Access Compliance Report

Public Rights-of-Way

(Curb Ramps)

Intersection ID: 13568	Main Street: ARLINGTON_AV	Cross Street: SOUTH_BV	Location: NW
ADA ID: 9F09ABBE7279	Ramp Type: BlendTrans1	Initial Pass/Fail: Pass	Overall Compliance: No
		Severity Score: 10

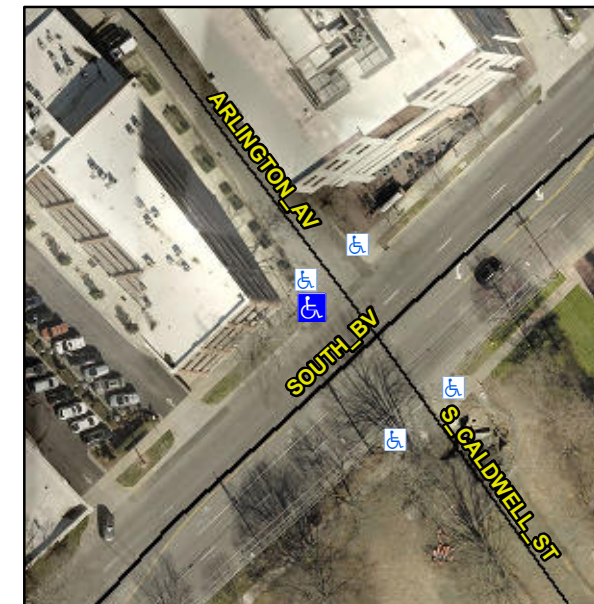
Not Found, R305, R304.5.3

Compliance	Description	Data	Compliance	Description	Data
N/A	Ramp Length (in)	42.0	Yes	BlendTrans Slope (%)	1.5
Yes	Ramp Width (in)	60.0	Yes	BlendTrans XSlope (%)	0.2
N/A	Flare Type LT	None	N/A	Flare Type RT	Sloped
N/A	Flare Slope LT (%)	N/A	N/A	Flare Slope RT (%)	1.9
N/A	Flare Traversable LT?	N/A	N/A	Flare Traversable RT?	No
Yes	Landing Length (in)	54.0	No	DWS Provided?	No
Yes	Landing Width (in)	53.0	N/A	DWS Contrast?	No
Yes	Landing Slope (%)	1.6	N/A	DWS Length (in)	N/A
Yes	Landing X Slope (%)	1.1	N/A	DWS Full Width?	No
N/A	Landing Curb? (Y/N)	No	N/A	DWS Offset (in)	N/A
N/A	Shared Landing?	Yes			
Yes	Gutter Ponding?	No	Yes	Gutter Slope (%)	0.2
Yes	Gutter Lip Ht (in)	0.0	No	Gutter X Slope (%)	2.1
N/A	Painted X Walk1?	No	N/A	Painted X Walk2?	N/A
	X Walk 1 Direction	To SE		X Walk 2 Direction	N/A
	X Walk 1 Width (in)	N/A		X Walk 2 Width (in)	N/A
	X Walk 1 Slope (%)	5.5		X Walk 2 Slope (%)	N/A
	X Walk 1 X Slope (%)	0.3		X Walk 2 X Slope (%)	N/A

N/A	Ramp inside XWalk1?	N/A	N/A	Ramp inside XWalk2?	N/A
	Road Slope (%)	0.3		Clear Space?	Yes
	Road X Slope (%)	5.5	N/A	Clear Space to XWalk (in)	N/A
Yes	Any Obstructions?	No	Yes	Storm Grate/Utility Hazard?	No
	Obstruction Type			Storm Grate/Utility Type	
		N/A			N/A
			Yes	Surface Condition? (G/P)	Good
			No	Curb Slope (%)	22.1

Remove & Replace Curb Ramp With Two New Directional Ramps or Equivalent. Remove & Replace Gutter.
